**Report: TAB Report**  
**Function: Test, Adjust, & Balance**  
**Date: 11/07/2025**  
**Completed By: National TAB**

**06-09-25 WAWA #6305 WAYCROSS, GA**

Wawa  
260 West Baltimore Pike  
Wawa, PA 19063

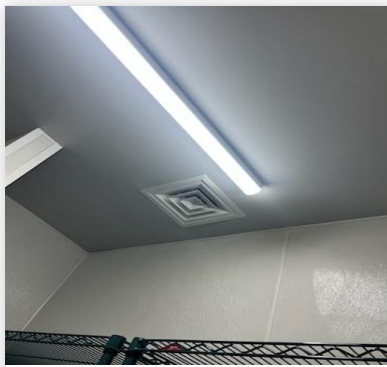
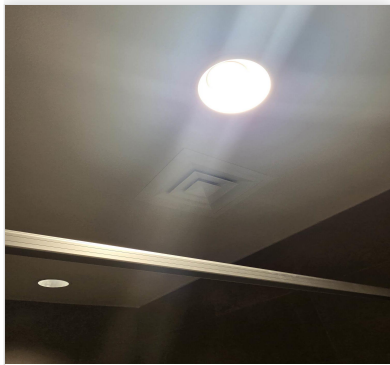
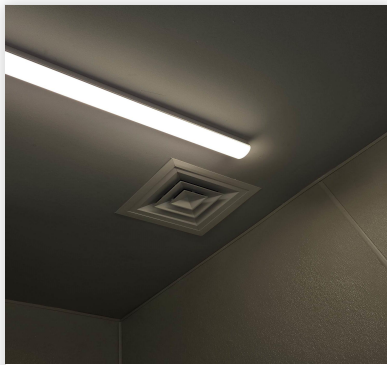
**Issue Name :** EF1-1and EF4-4 have wrong diffuser type installed  
**Description :** Currently installed are CD-4 supply diffusers when GRD calls for G-3 exhaust diffusers.  
**Created By :** National TAB                      **Assigned To :** National TAB - Will Turnbough  
**Status :** Open  
**Priority :** Urgent                                      **Asset Tag :**  
**Originated Date :** 06/10/2025 - Ian Fuller - National TAB

- **11/07/2025 National TAB - Stephen Tassinaro**
  - Supply type diffusers still installed on exhaust.

- 
- **09/23/2025 National TAB - Stephen Tassinaro**
    - Unresolved 9/22.
- 
- **06/30/2025 National TAB - Ian Fuller**
    - Issue not resolved as of 6/30. Supply type diffusers still installed.

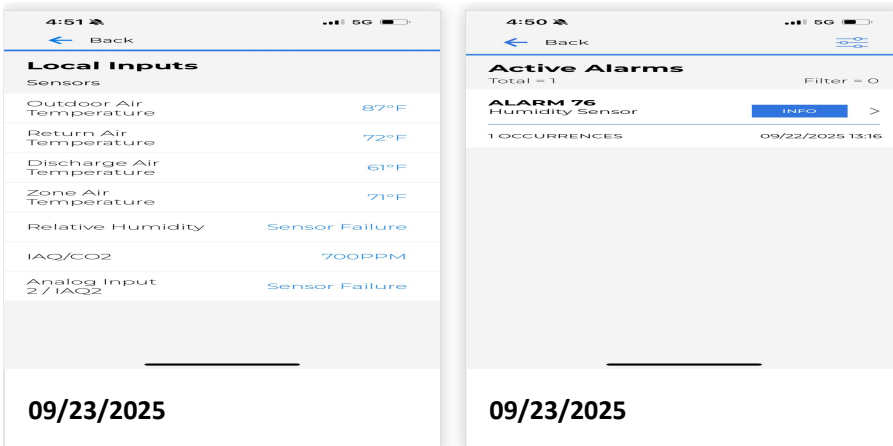
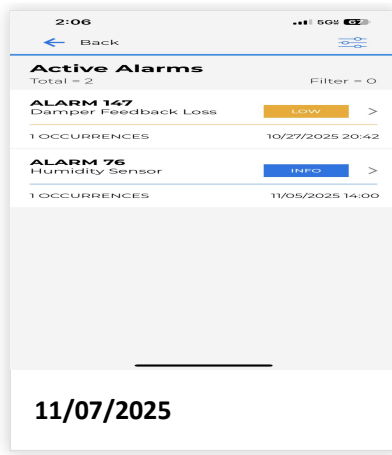
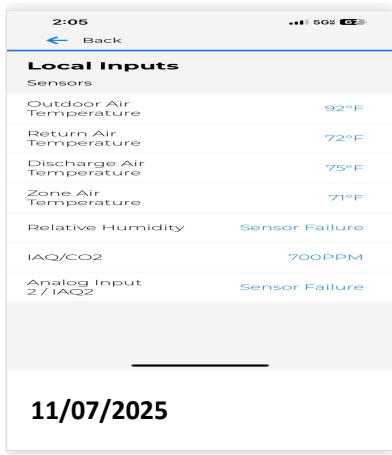
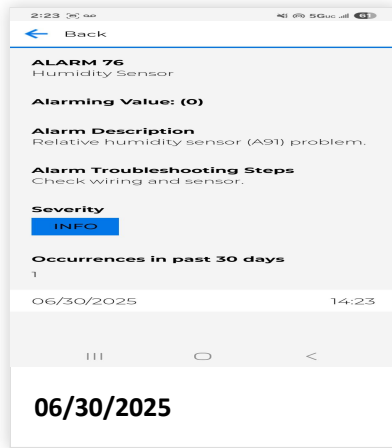
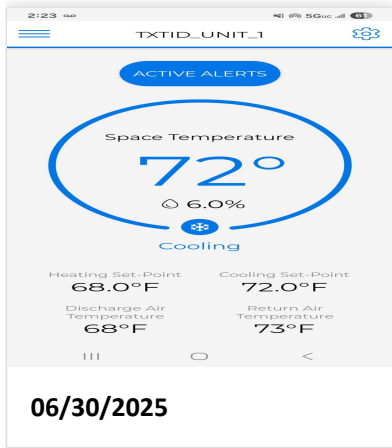
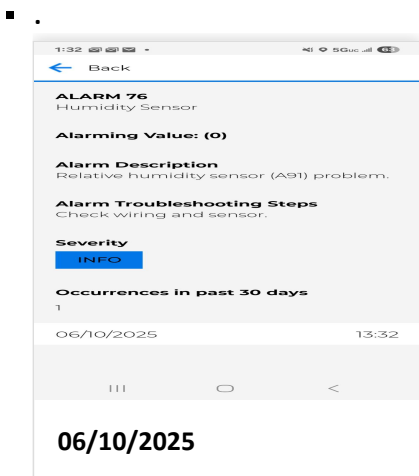
**Issue Name :** RTU-1 humidity sensor  
**Description :** Humidity sensor is not reading correct humidity. Sensor starts to read at 8% then jumps to around 35% when humidity in the building is around 53 % RH. Humidity sensor wiring is per spec. **VERIFY ALL THREE UNITS ARE READING A REALISTIC RELATIVE HUMIDITY IN ORDER TO CLOSE ISSUE.**

- **11/07/2025 National TAB - Stephen Tassinaro**
  - Sensor still reading between 8% and then sensor failure. Likely a short in the wiring or terminals landed incorrectly.

- **09/23/2025 National TAB - Stephen Tassinaro**
  - RTU-1 is still alarming for humidity sensor. Unresolved.

- **06/30/2025 National TAB - Ian Fuller**
  - Issue nit resolved as of 6/30. Core alarm is still present on system.

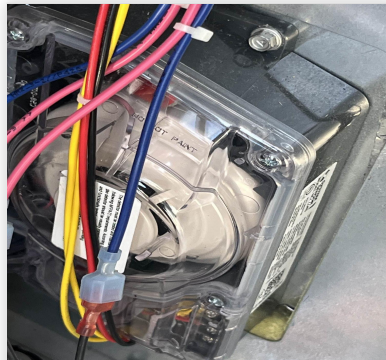
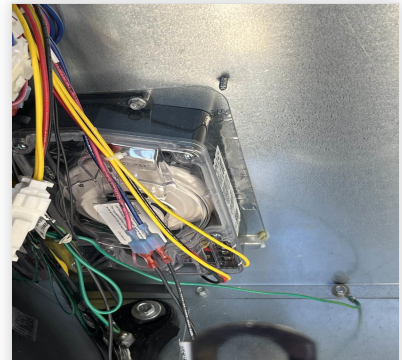
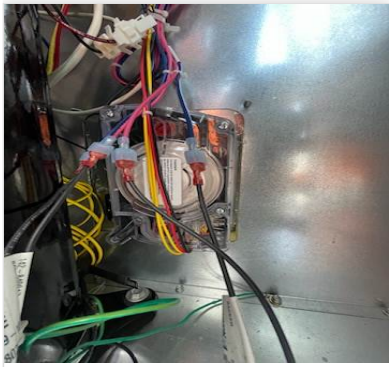
**Issue Name :** Smoke detector dust plugs are still in unit  
**Description :** Recommended to remove dust plugs in all units before store operation.  
**Created By :** National TAB **Assigned To :** National TAB - Will Turnbough  
**Status :** Closed  
**Priority :** Medium **Asset Tag :**  
**Originated Date :** 06/10/2025 - Ian Fuller - National TAB

- **11/07/2025 National TAB - Stephen Tassinaro**
  - Dust plugs still installed on return side smoke detector heads.

- **09/23/2025 National TAB - Stephen Tassinaro**
  - Unresolved 9/22.

- **06/30/2025 National TAB - Ian Fuller**
  - Issue not resolved as of 6/30.

- **12/19/2025 National TAB - Will Turnbough**
  - closing based on GC pics

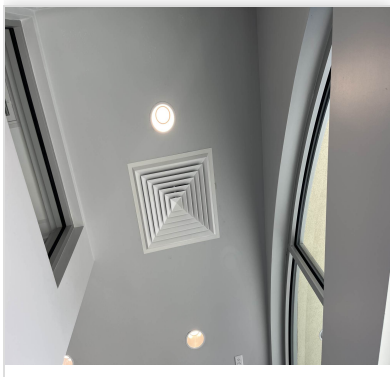
**Issue Name :** Transfer duct in vestibule has wrong diffuser installed.  
**Description :** A supply type CD-2 diffuser is installed when the GRD specifies a return type G-2 diffuser is installed. The correct diffuser type needs to be installed.  
**Created By :** National TAB                      **Assigned To :** National TAB - Will Turnbough  
**Status :** Open  
**Priority :** Medium                              **Asset Tag :**  
**Originated Date :** 06/30/2025 - Ian Fuller - National TAB

- **11/07/2025 National TAB - Stephen Tassinaro**
  - Supply type diffuser still installed on vestibule transfer grille.

- Unresolved 9/22.
